Chapter 18.28 Tukwila Urban Center (TUC) District

W:\Long Range Projects\Southcenter Plan\Plan 2011\Book 2\FINAL PC BOOK2_6.12.12_with markups.docx

Figure 19 Cornices

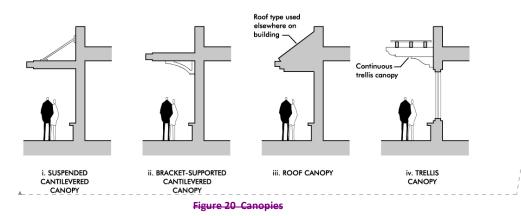
Comment [LM4]: Since these are guidelines they have been moved to the Southcenter Design Manual.

a. Façade Offset

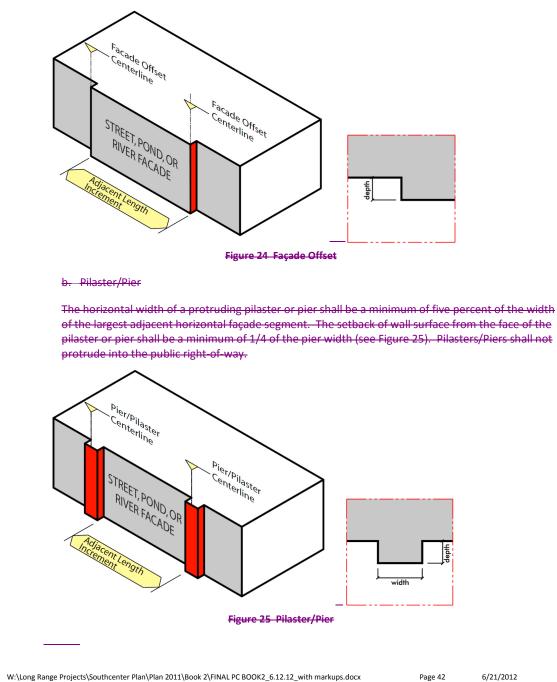
(1) The horizontal depth of a façade offset shall be a minimum of five percent of the width of the largest adjacent horizontal façade segment. If building materials are used to create a contrast in color and texture between the wall segments the depth may be reduced to 3 percent of the width of the largest adjacent horizontal façade segment (see Figure 24). **Comment [LM5]:** These vertical modulation types have been moved to the Design Manual.
